Item ID: D206-667-203RLC Accept *N9000040100* Setup Start *NS1*
 Revision ID: Stop *NS2*
 Item Name: Aft Crosstube - High 206L / L1 / L3 / L4
 Start Date: 4/24/2015 Start Qty: 1.00 *1* Cust Item ID:
 Required Date: 4/24/2015 Req'd Qty: 1.00 *1* Customer:
 Reference:

DART AEROSPACE LTD		Work Order:	132094
Description: Crosstube High Aft (206L)		Part Number:	D206-667-203
Inspection Dwg: D206-667-243 Rev: C		Page 1 of 1

DRAWING NO. D206-667-243	TITLE CROSSTUBE ASS'Y (206L HIGH AFT)	REV. C	DART AEROSPACE LTD ENGINEERING ORDER		D.E.O. NO. D206-667-243-C-1	SHEET NO. SHEET 1 OF 1	SCALE NTS
DRAWN <i>qp</i>	CHECKED <i>ASS</i>	MFG. APPR. <i>RB</i>	APPROVED <i>MP</i>		DE APPR. <i>#</i>		
DATE 11.07.15	DATE 11.07.20	DATE 11.07.21	DATE 11/07/21		DATE 11.07.21

REPLACE MAGNOBOND WITH PROSEAL.

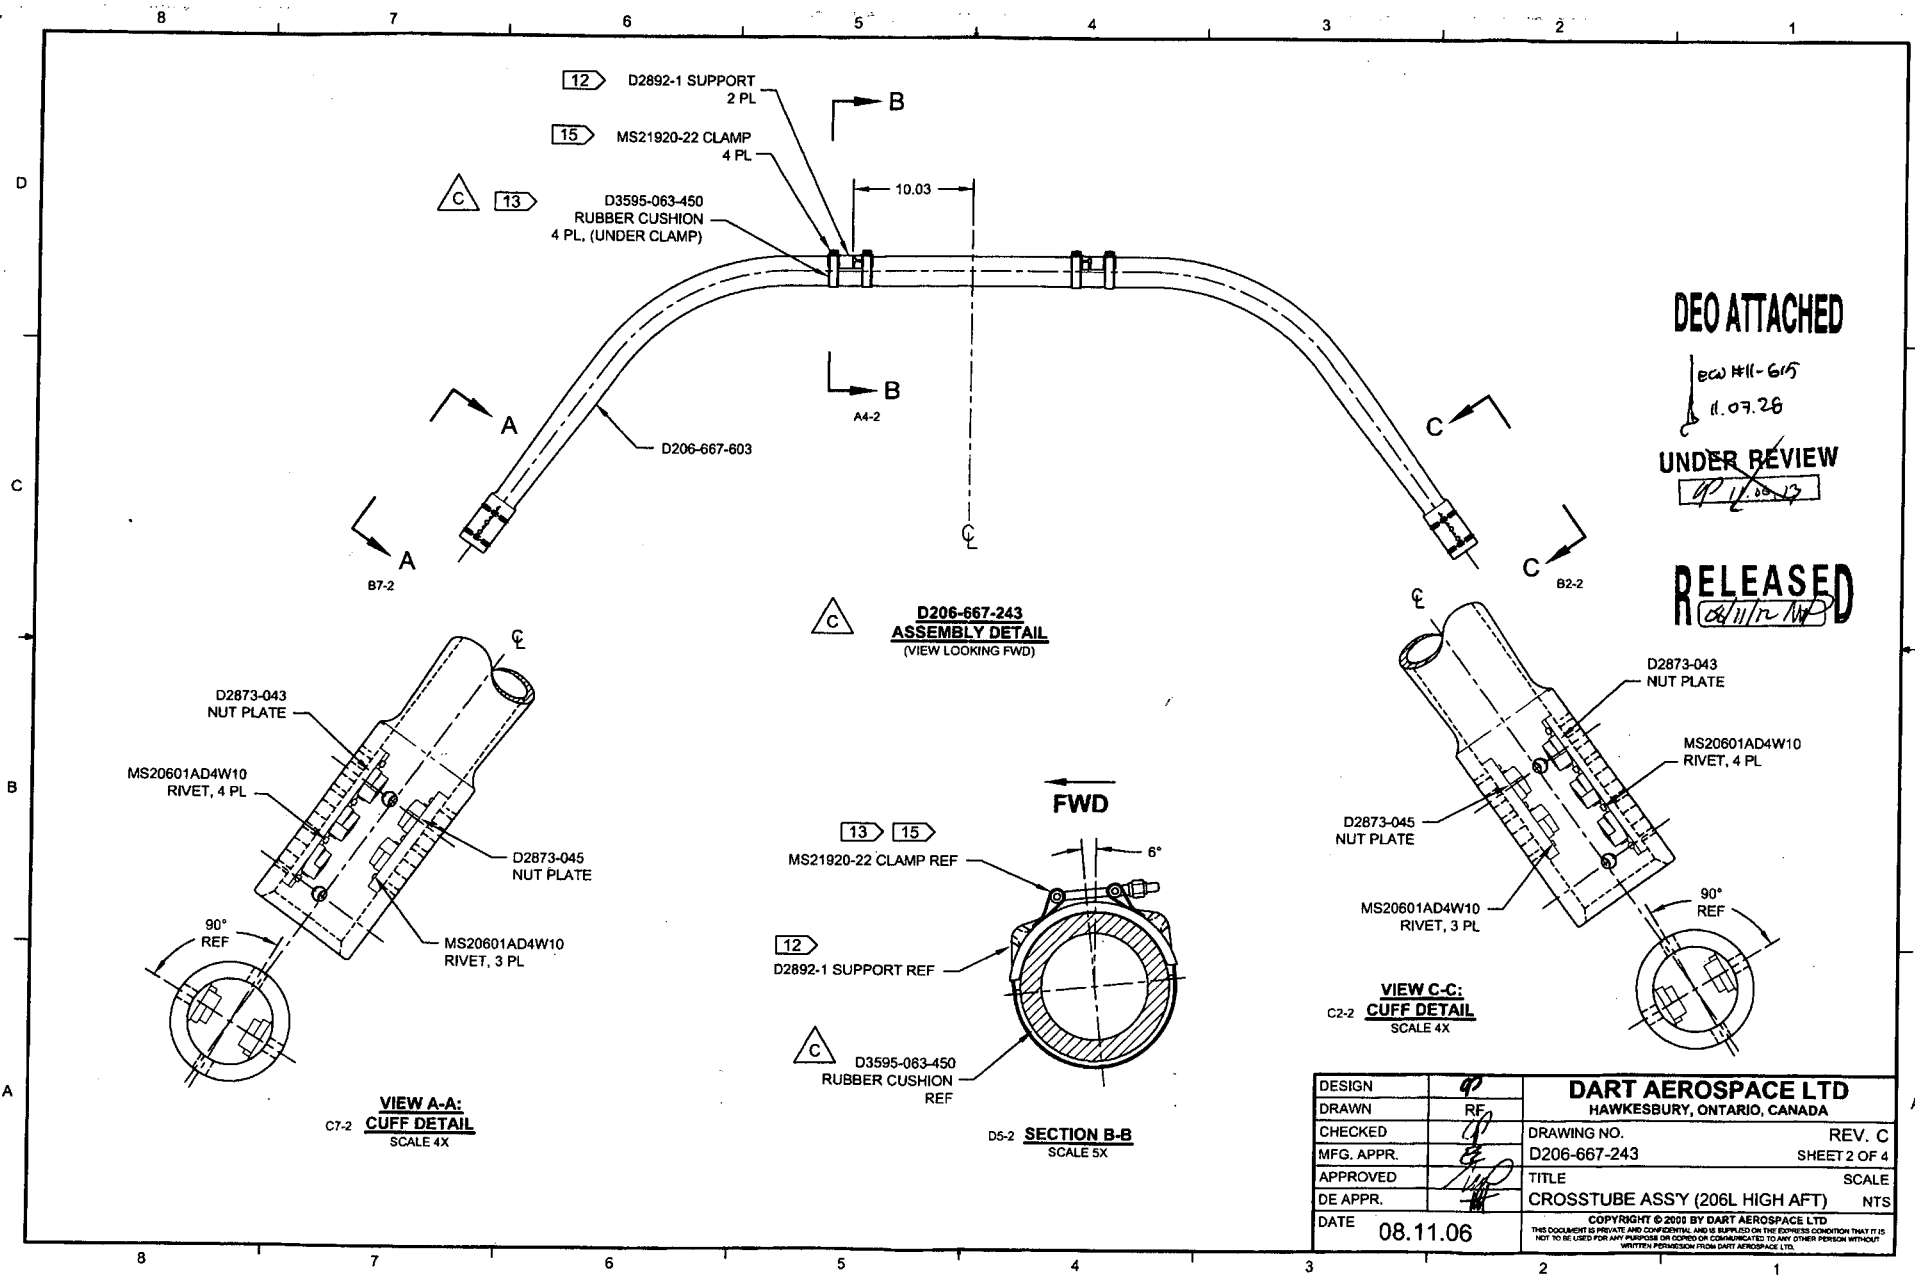
NOTE 12 & 15, SHEET 1 IS AMENDED AS FOLLOWS:

Item	Qty -243	Part Number	Description
9	A/R	PROSEAL 890 B-2	SEALANT, AMS-S-8802 CLASS B-2

9	A/R	MAGNOBOND 6398	ROCKWELL SPECIFICATION RBO-120-023 ADHESIVE (TEXTROM/BELL SPEC. 299-947-100, TYPE II, CLASS 2 ADHESIVE)
---	-----	----------------	---

- 12) TO INSTALL D2892-1 SUPPORT: ABRABE MATING SURFACE OF SUPPORT AND CROSSTUBE WITH 180-GRIT SANDPAPER AND REMOVE RESIDUE WITH MEK (OR EQUIVALENT). APPLY A 0.04" TO 0.07" THICK LAYER OF PROSEAL 890 CLASS B-2 (OR AMS-S-8802 CLASS B-2) SEALANT TO MATING SURFACE OF SUPPORT.
- 15) TORQUE CLAMPS 80 TO 100 IN-LB. ENSURE AT LEAST 1.5 THREADS SHOWING IN SAFETY AND THAT NUT HAS NOT BOTTOMED-OUT AFTER TORQUING. **PRIOR TO PACKAGING, RE-CHECK TORQUE ON CLAMPS AFTER PROSEAL 890 SEALANT HAS CURED FOR 72 HOURS.**

- 12) INSTALL D2892-1 SUPPORT USING 0.03" TO 0.08" THICK LAYER OF MAGNOBOND 6398 PER QSI 015. LET CURE FOR 12 HOURS AFTER INSTALLATION AND PRIOR TO PACKAGING.
- 15) TORQUE CLAMPS 80 TO 100 IN-LB. ENSURE AT LEAST 1.5 THREADS SHOWING IN SAFETY AND THAT NUT HAS NOT BOTTOMED-OUT AFTER TORQUING.
